From: [Ranelli, Matt](#)  
To: [Maureen Fitzgerald](#)  
Subject: RE: 51 Daniels Avenue wetland applications  
Date: Tuesday, May 20, 2025 2:02:13 PM  
Attachments: [image001.png](#)  
[2025-05-20 LEARN Early Childhood School - Conservation Comments.pdf](#)

Thank you again for the site visit with Dean. We are attaching the revised drawings with changes to address the comments and concerns. There is a short sheet-by-sheet description of the changes below if it is helpful for your review. Please let me know if you want to discuss any of the changes – hopefully we hit the mark.

Sheet-by-Sheet summary:

DRAWING NUMBER:  
**CE101**

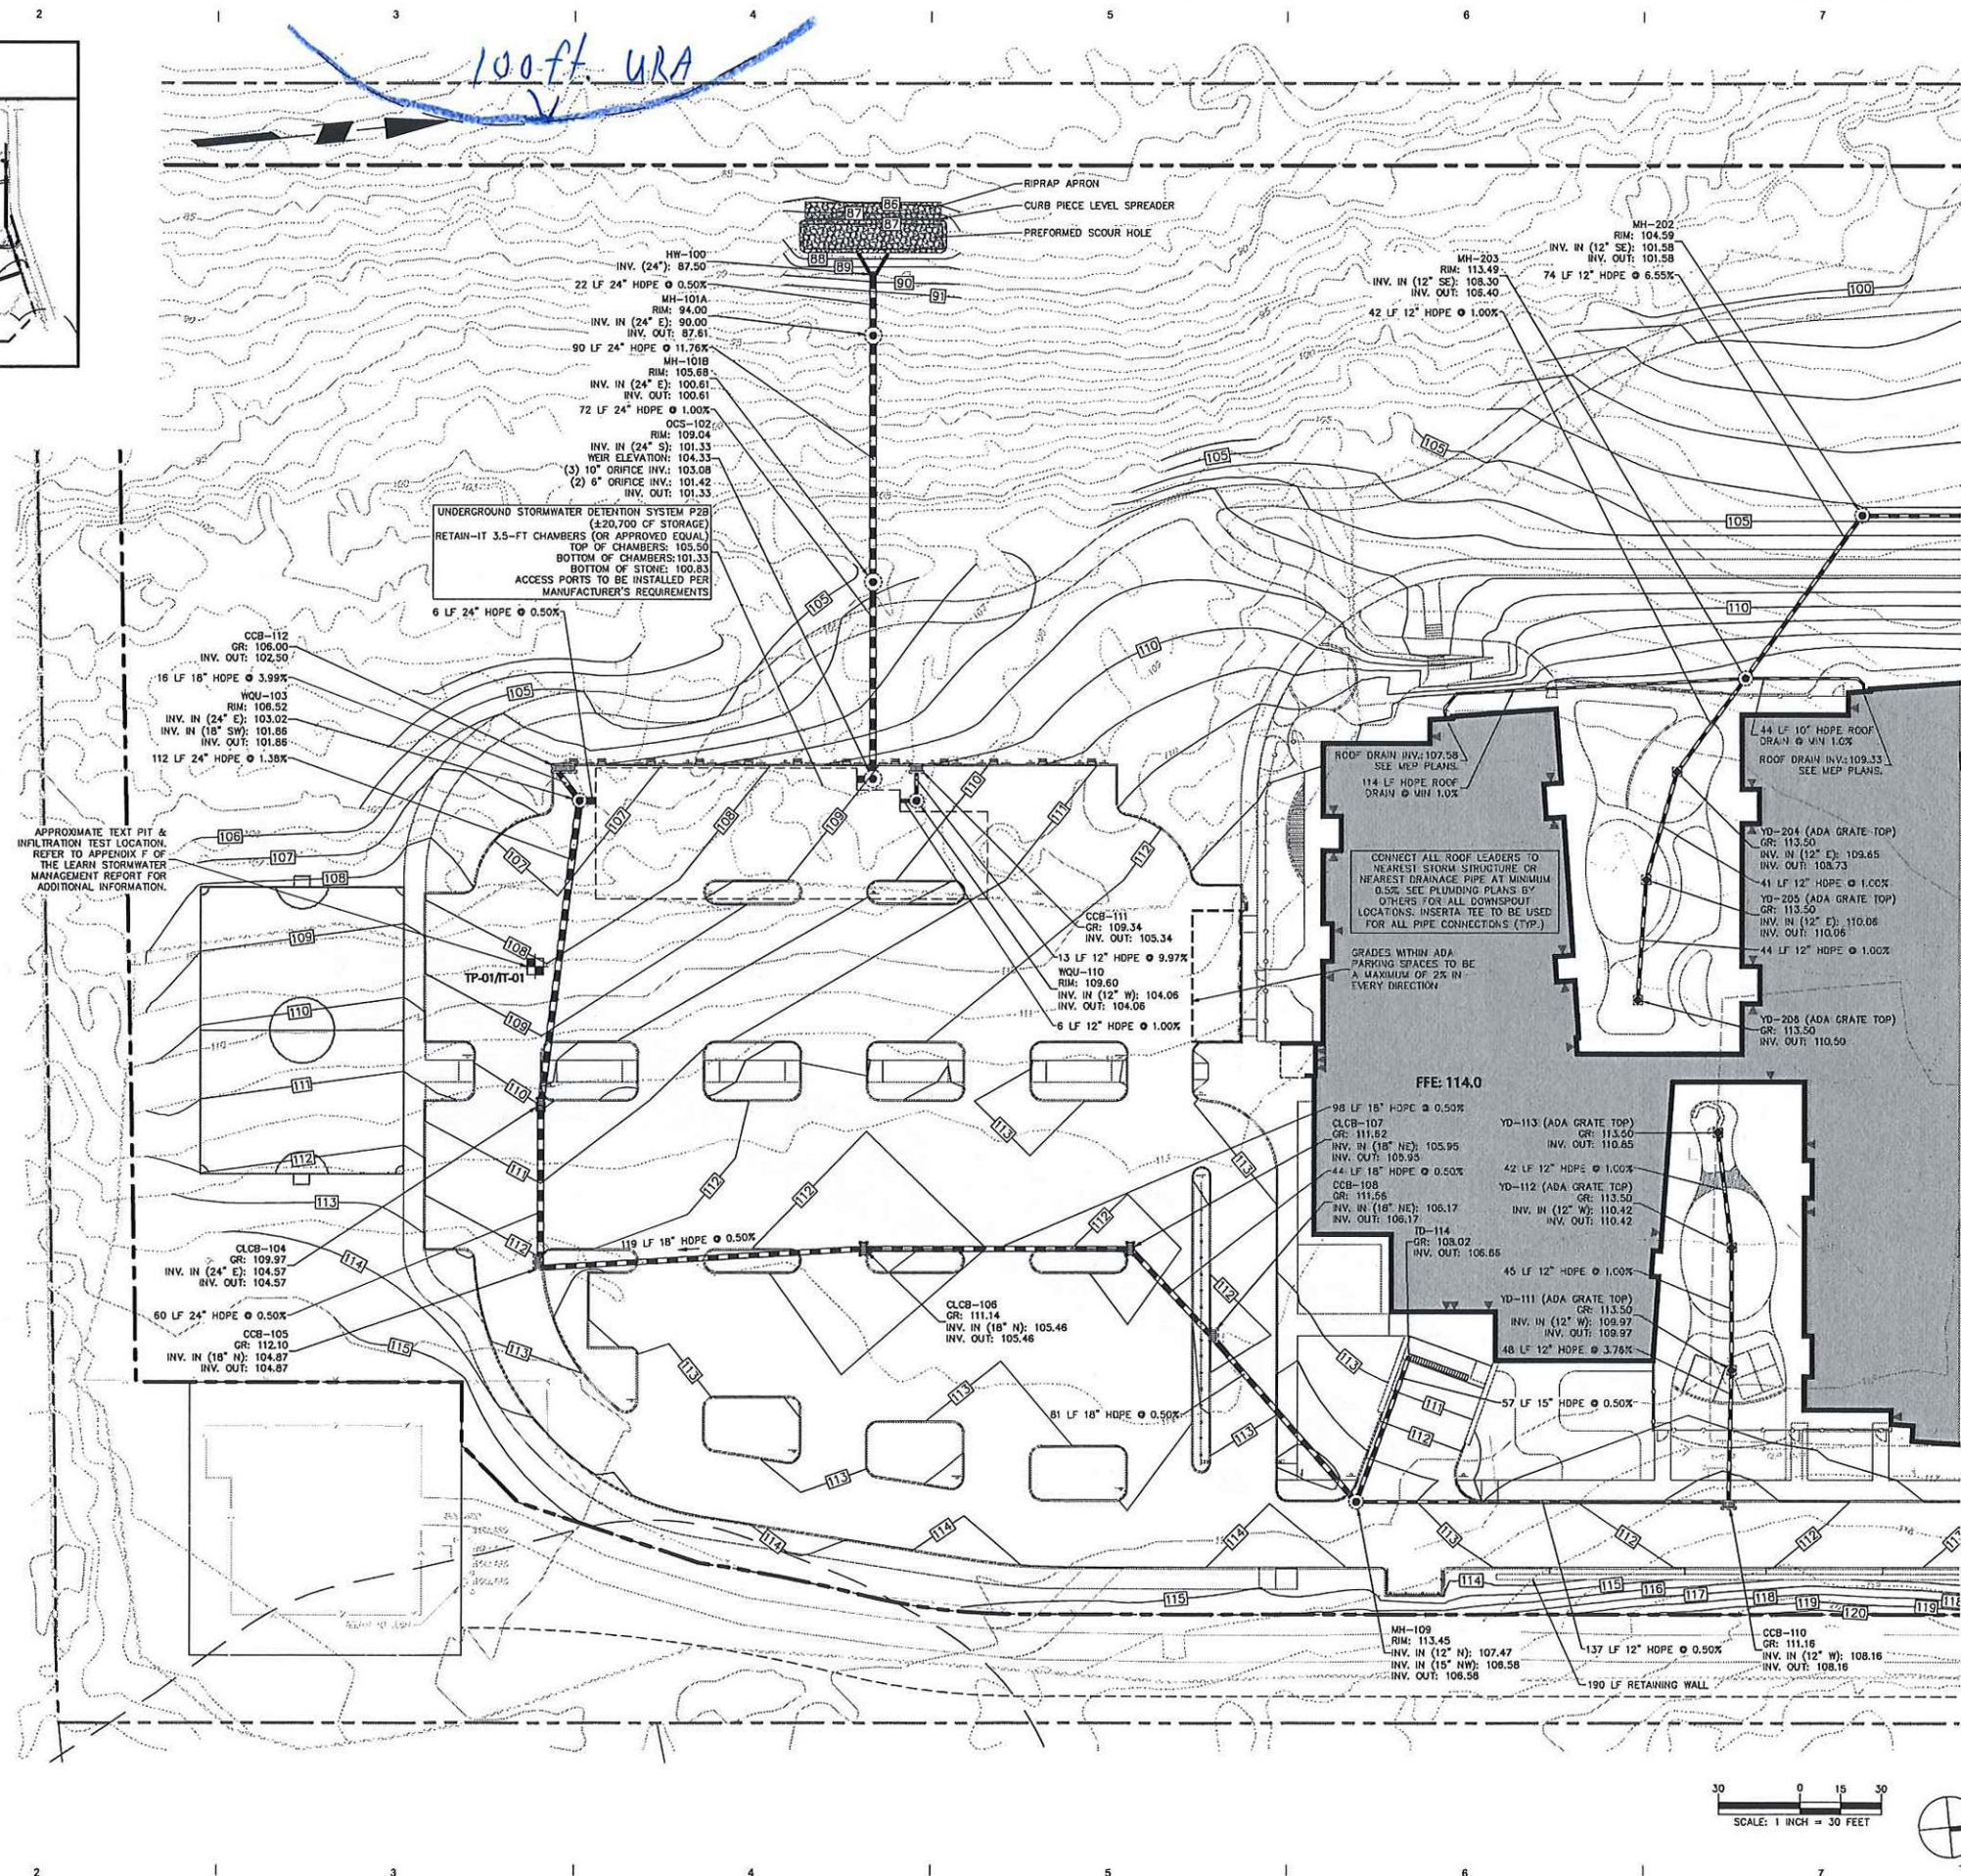
4. Sheet CE101 – Additional E&S controls have been provided for the relocated outfall.
5. We will provide the E&S phasing plan as part of the Planning and Zoning review (as well as being included later in the CTDEEP Stormwater GP submission) it will show the locations of temporary stormwater features (e.g., diversion berms, basins, etc.) which will be located outside of the 100' URA.
